PROJ. NO.: G25003-01
SUBJECT: Addendum No. 1
Courts Renovation
City of Fort Oglethorpe, Georgia

ADDENDUM NO. 1
COURTS RENOVATION
CITY OF FORT OGLETHORPE, GEORGIA
CTI PROJECT NO. G25003-01

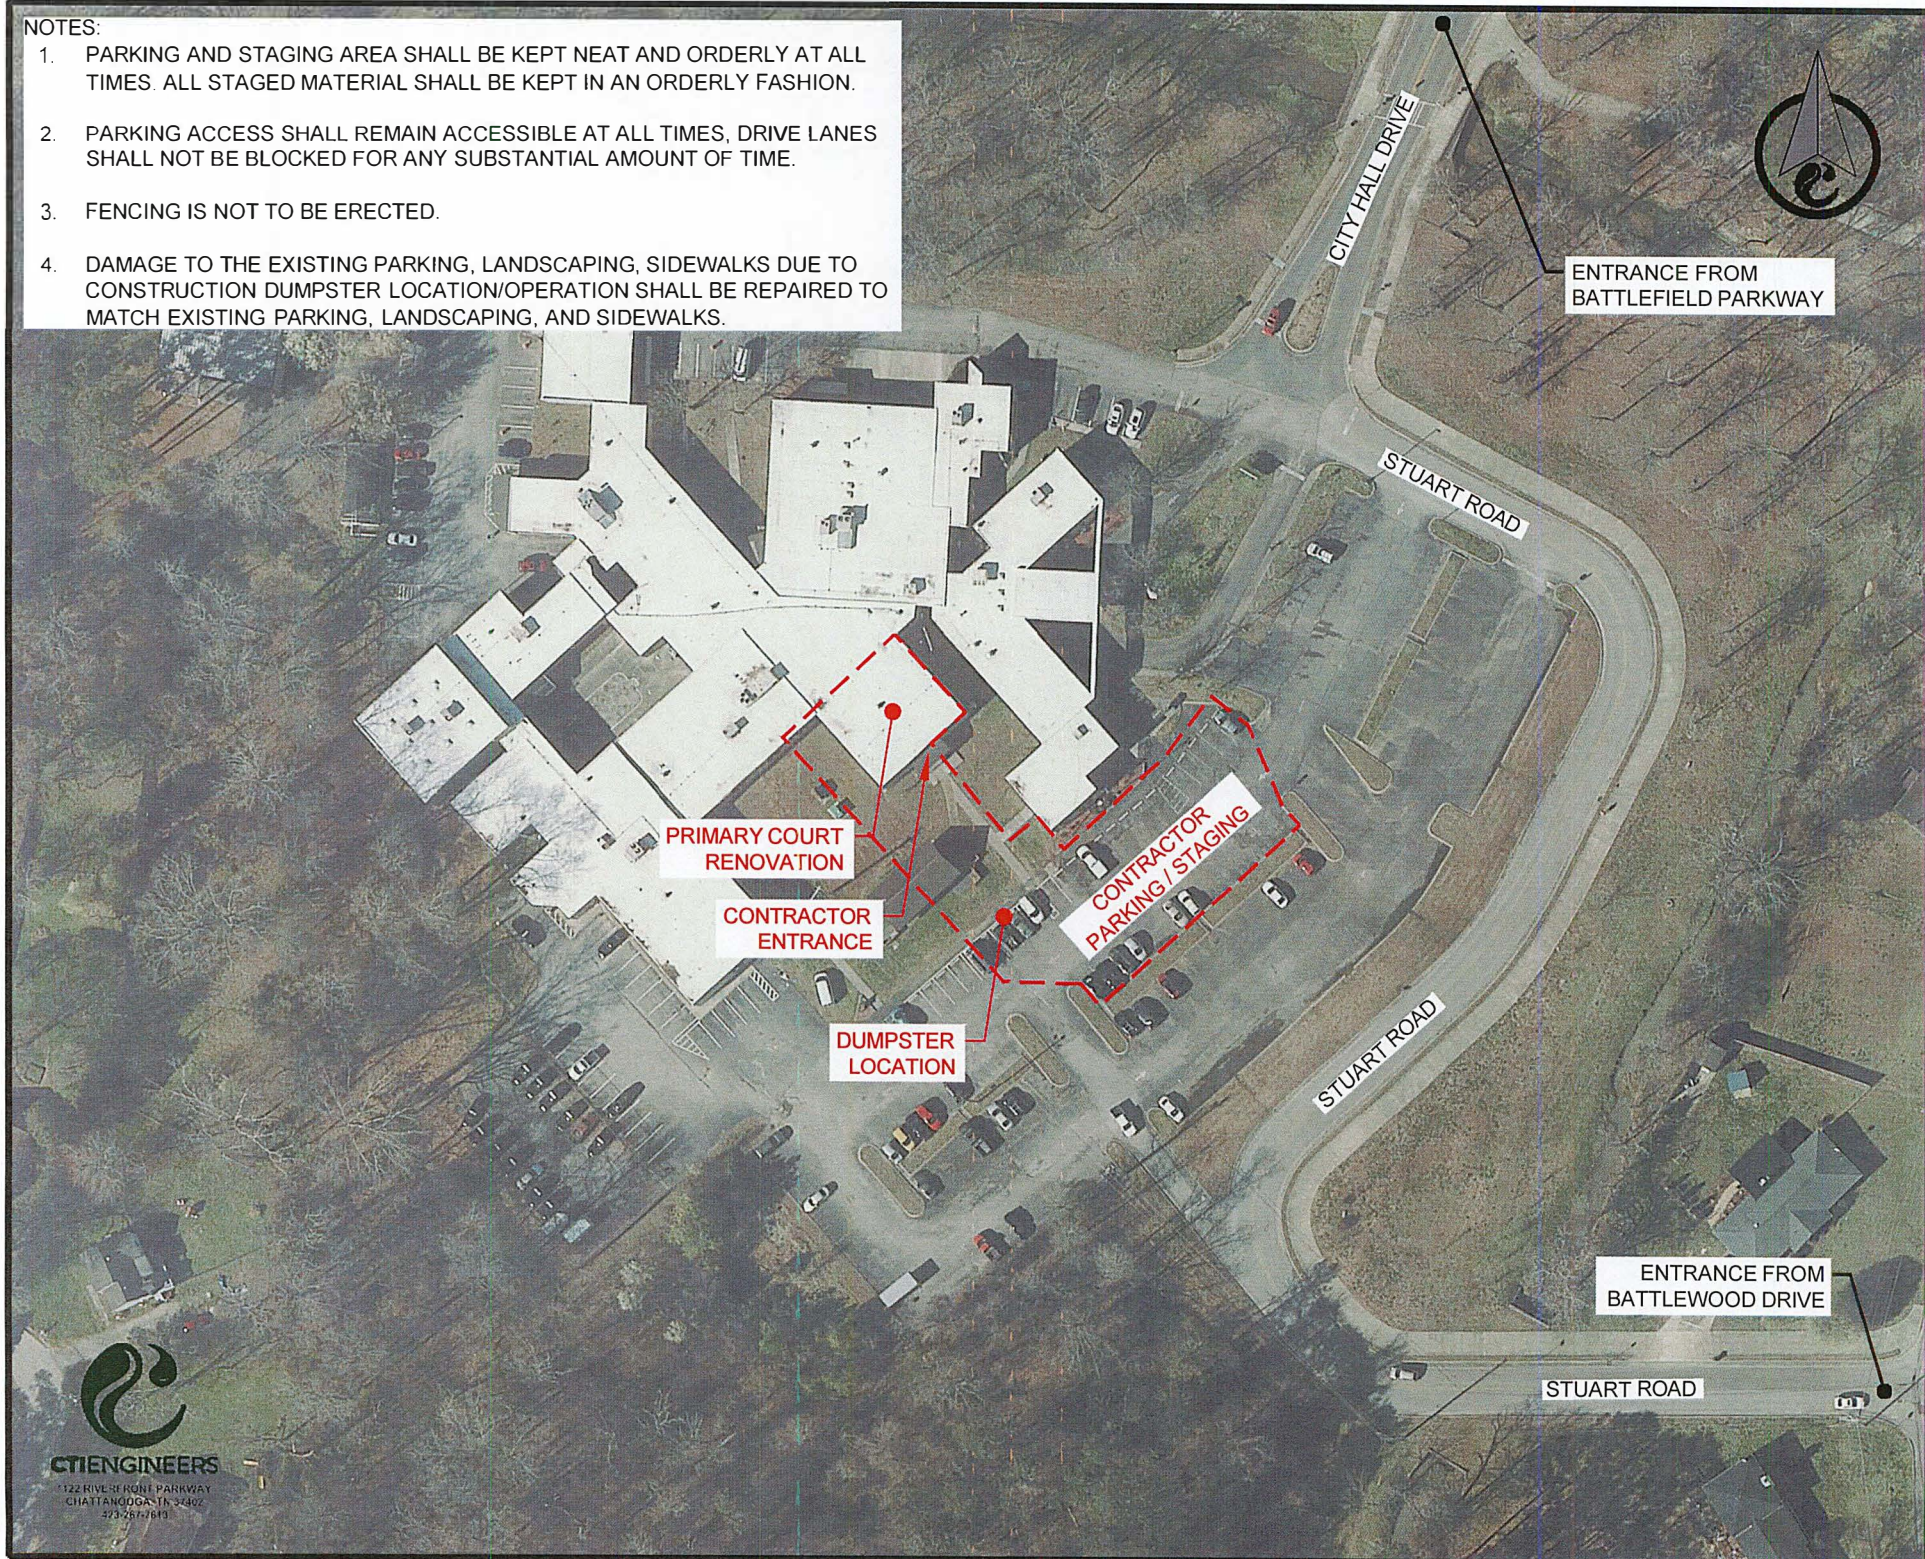
7. **Contractor Staging area, Dumpster and Parking Response:**

- a) See attached site plan from CTI Engineers.
- b) Damage to the existing parking, landscaping, sidewalks due to construction dumpster location/operation shall be repaired to match existing parking, landscaping, and sidewalks.
